SUBJECT: PLANS AND PROPOSAL ADDENDUMS

PROJECT: F 2023(485)

CONTROL: 0047-14-087

PROPOSAL ADDENDUMS

IRRIGATION PLAN PLANTER BED B1

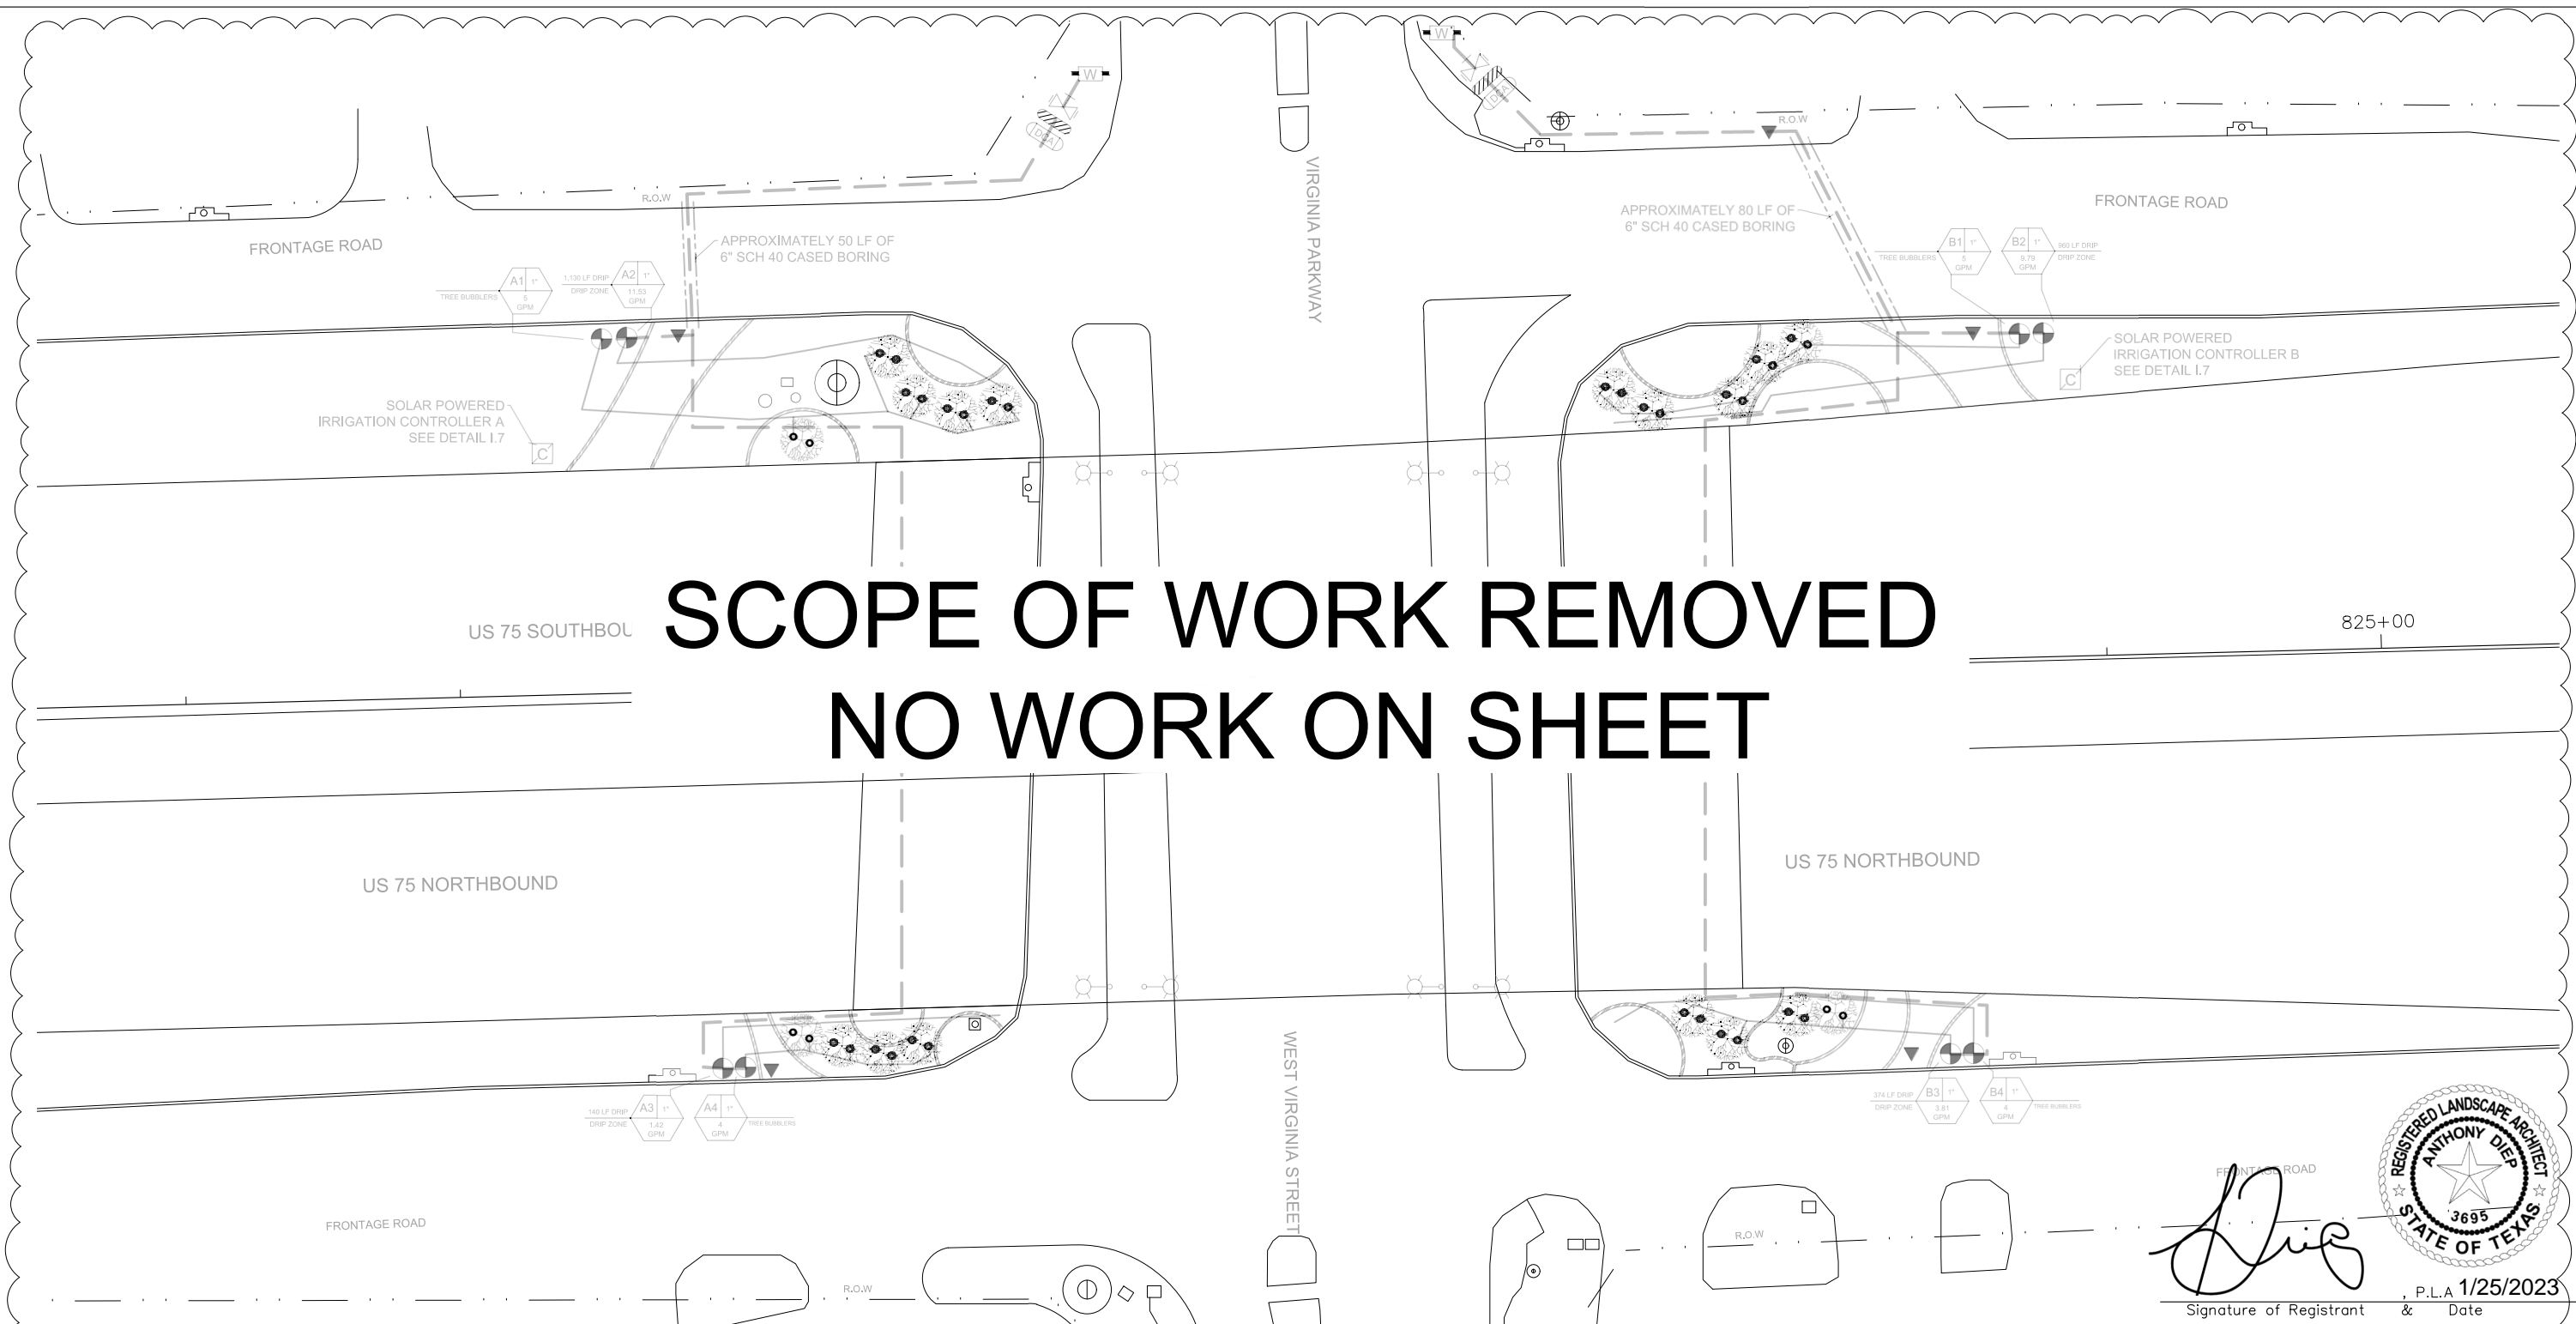
SCOPE OF WORK REMOVED NO WORK ON SHEET
